Product Change Notice (PCN)

LFPCN# 41497

Product Change Notification for LA, UltraMOV, ZA and C-III Series Radial Lead Varistors

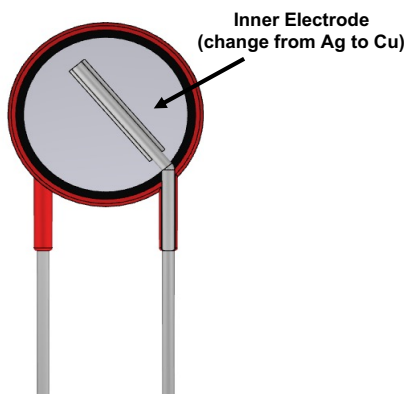
Littelfuse would like to notify you of a change related to LA, UltraMOV, ZA and C-III Series Radial Lead Varistors' inner electrode as shown in below picture.

This change has no impact to product's original electrical parameters, dimensions, quality, reliability and part numbers. New product samples and qualification test report are available upon request.

This change will be implemented for **LA & UltraMOV Series starting from April 1st, 2024** and **ZA & C-III Series starting from July 1st, 2024**. During the change transition period, customers are expected to receive current and new products until current product inventory in Littelfuse warehouses and distribution channels are depleted.
